Steven M. Clouse WRC Electrical System Improvements Phase 2A
Solicitation Number: CO-00443
Job No.: 21-6507

ADDENDUM 3
August 23, 2021

10E40
196 OF 328

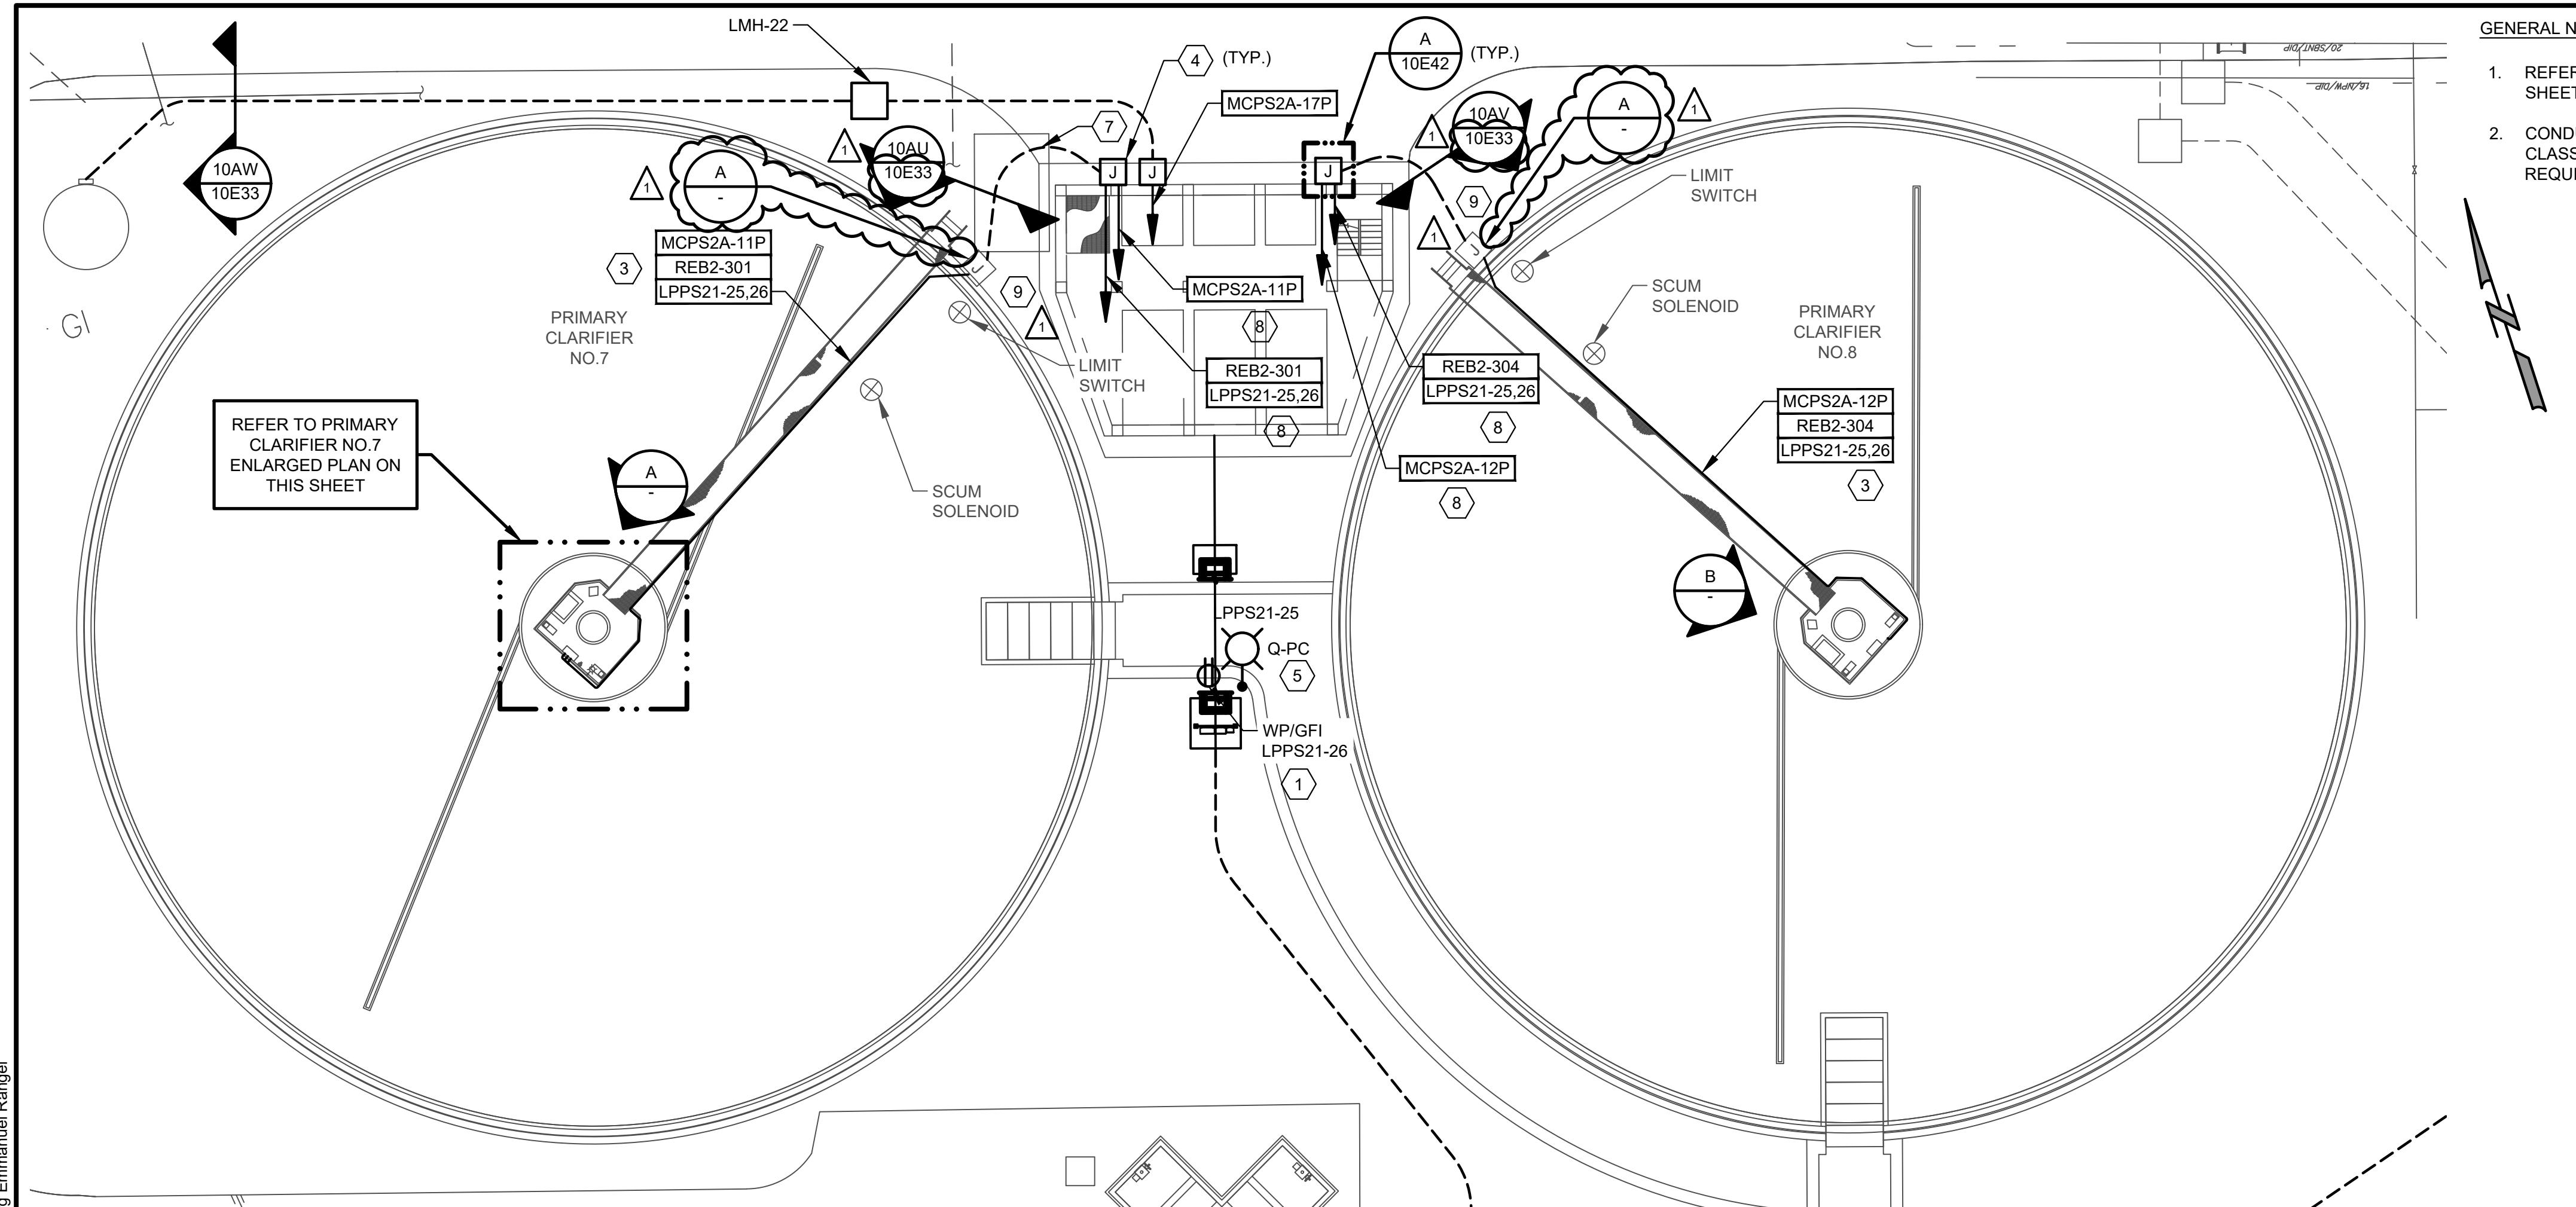
10. Sheet 10E11 & 10E40 refers to Section D on Sheet 20E71 for Power Terminal Boxes PTB-PS2-1 & PTB-PS1-1. Please provide the detail sheet..

Response: Detail added to sheet 10E11. Refer to Changes to the Plans, items “d. 10E11” and “k. 10E40”
